HUNTER ADDITION TO **CEDAR POINT ROAD SUBDIVISION**

APPLICATION NUMBER 20 DATE March 20, 2003

REQUEST Subdivision

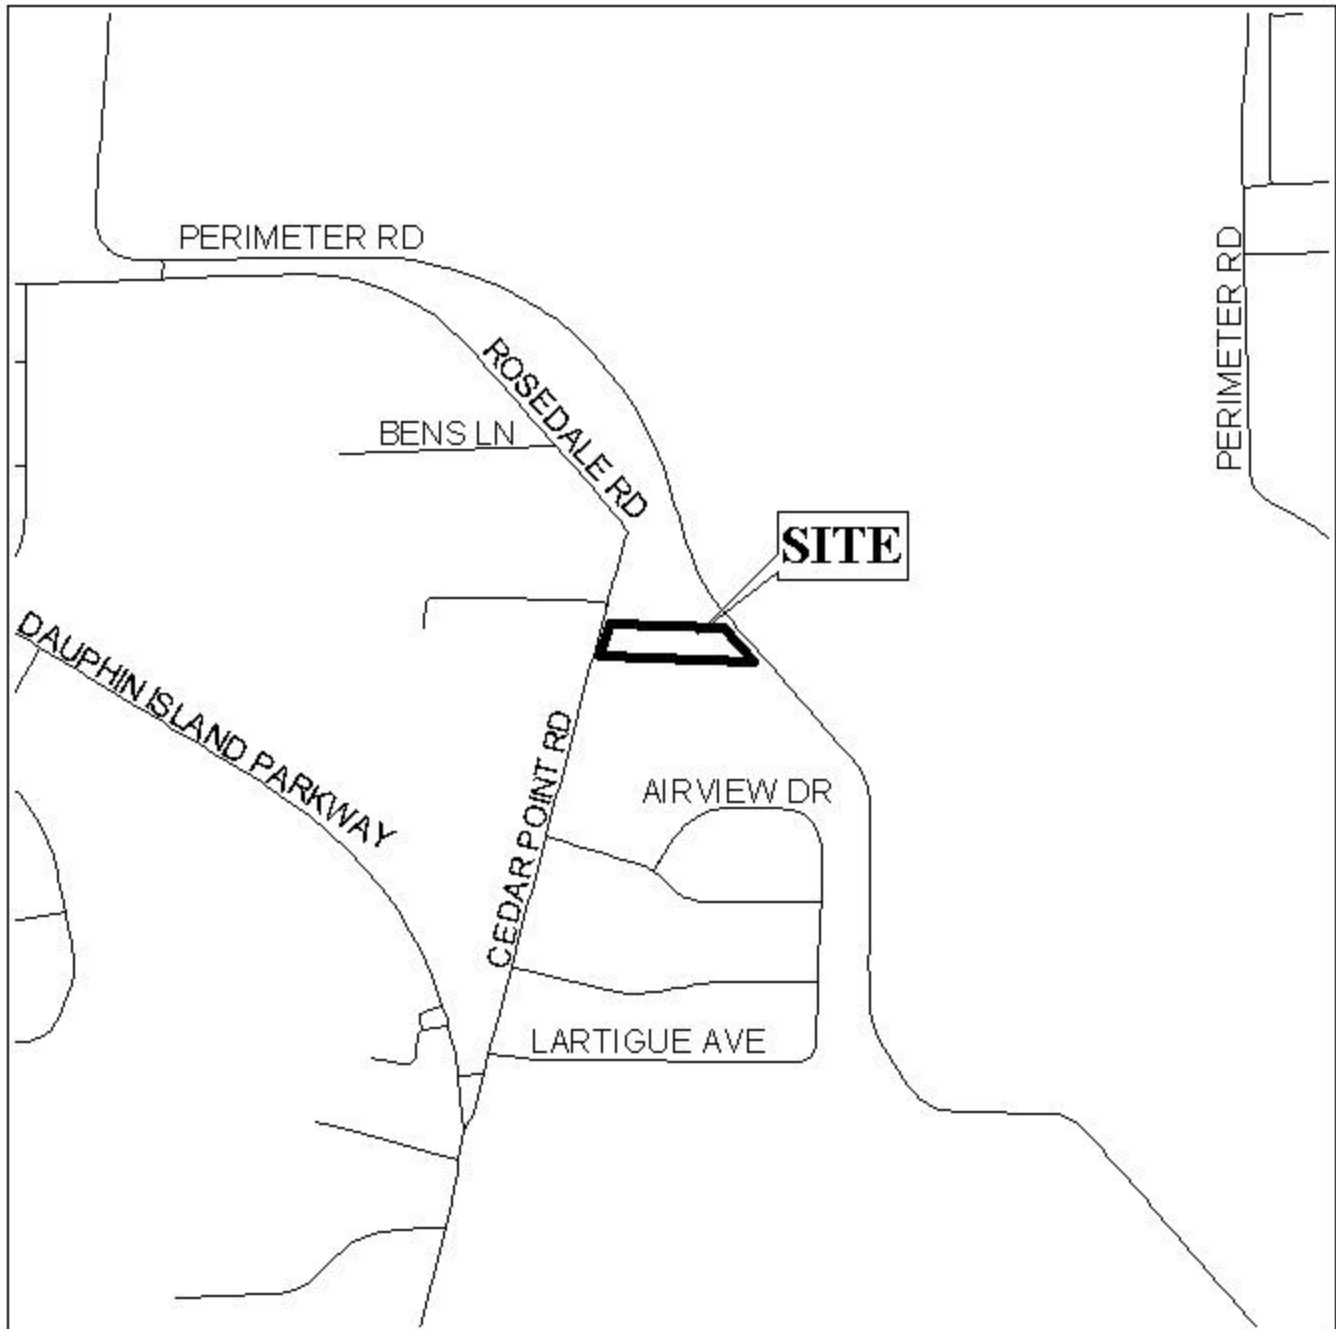
As illustrated on the Vicinity Map, the shaded area was deeded off via a metes and bounds description in 1997 and should be included in the subdivision.

Lots 1 and 2 exceed the maximum width to depth ratio as recommended by the Subdivision Regulations; therefore, a waiver of Section V.D.3. would be required.

Based upon the preceding, this application is recommended for holdover until the April 3rd Planning Commission meeting to allow the applicant to include the remainder of the property and additional property owner information for notification; or to provide the staff with documentation, in this case a deed prior to 1952, illustrating the subdivision of a parcel of the parent tract. This information would be required by March 24th.
